D117-762-011
Job Sheet 167189-A

DART SERVICE INSTRUCTION

TO AMEND INSTALLATION INSTRUCTIONS IIN-D117-762 REV. E AND
INSTRUCTIONS FOR CONTINUED AIRWORTHINESS ICA-D117-762 REV. 4

A	NEW ISSUE	RF	17.01.09
REV.	DESCRIPTION	BY	DATE
DESIGN	RF	DART AEROSPACE, LTD EUGENE, OR	
DRAWN	RF		
CHECKED	WK	DRAWING NO.	REV.A
MFG. APPR.	N/A	DSI 9771	SHEET 1 OF 2
APPROVED	HS	TITLE	SCALE
DE APPR.		GHL UPGRADE KIT	NTS
DATE	17.01.09	COPYRIGHT © 2017 BY DART AEROSPACE USA, INC THIS DOCUMENT IS PRIVATE AND CONFIDENTIAL AND IS SUPPLIED ON THE EXPRESS CONDITION THAT IT IS NOT TO BE USED FOR ANY PURPOSE OR COPIED OR COMMUNICATED TO ANY OTHER PERSON WITHOUT WRITTEN PERMISSION FROM DART AEROSPACE, LTD.

FIGURE 1 - GHL UPGRADE INSTALLATION

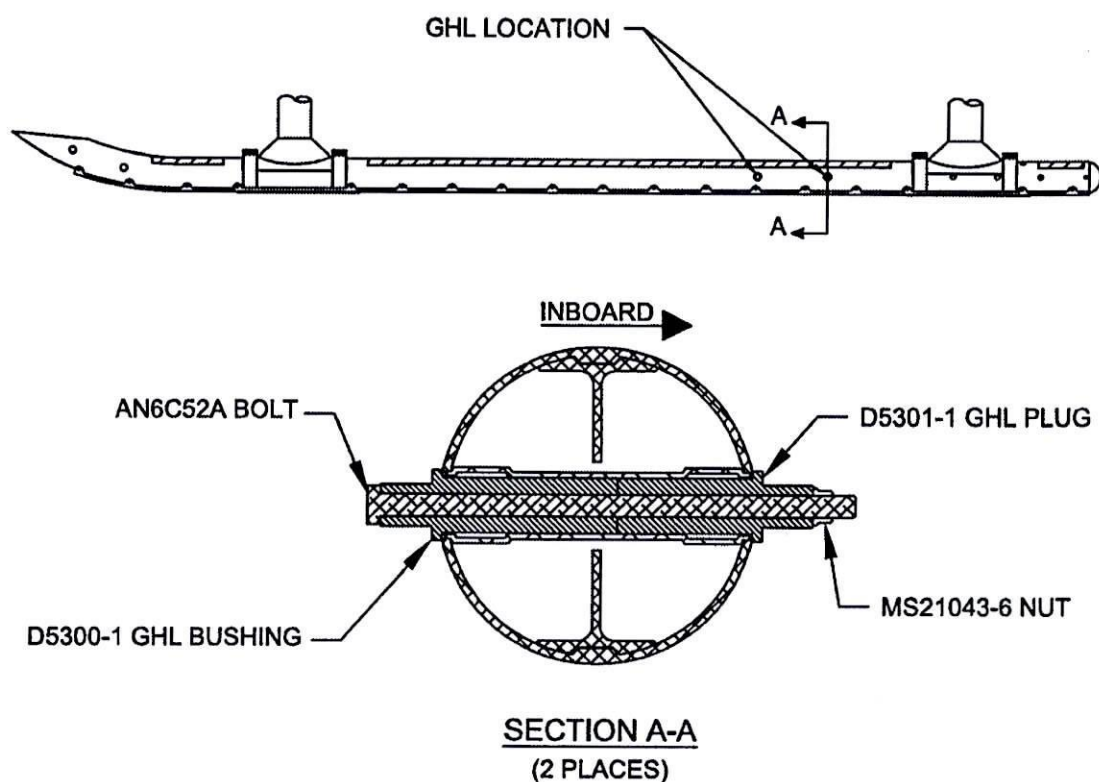
The purpose of this Dart Service Instruction (DSI) is to replace the ground handling lugs (D3864-1 Bushings, AN6C51A Bolts and MS21043-6 Nuts) on the D117-762-XXX Skid tubes with a structurally superior lug design (D5300-1 Bushings, D5301-1 Plugs, AN6C52A Bolts, MS21043-6 Nuts) as shown in Figure 1. The new hardware will be included in D117-762-011 @ CHG 004 and subsequent.

- 2.1 Loosely install (qty 2) D5300-1 GHL Bushing & (qty 2) D5301-1 GHL Plug wet with Proseal 890 or MIL-S-8802 Class B2 Sealant in location shown in Figure 1.
- 2.2 Install (qty 2) AN6C52A Bolts and (qty 2) MS21043-6 Nuts in accordance with Figure 1. Clean up squeezed out Proseal and apply fillet seal around D5300-1 & D5301-1.
- 2.3 Torque AN6C52A Bolts 160 - 190 in-lbs (18.1 - 21.5 N-m).

WAS

ITEM	QTY -011	PART NUMBER	DESCRIPTION
	X	D117-762-011	SKIDTUBE INSTALLATION
50	2	AN6C51A	BOLT
51	4	D3864-1	BUSHING
52	2	MS21043-6	NUT

IS

ITEM	QTY -011	PART NUMBER	DESCRIPTION
	X	D117-762-011	SKIDTUBE INSTALLATION
50	2	AN6C52A	BOLT
51A	2	D5300-1	GHL BUSHING
51B	2	D5301-1	GHL PLUG
52	2	MS21043-6	NUT
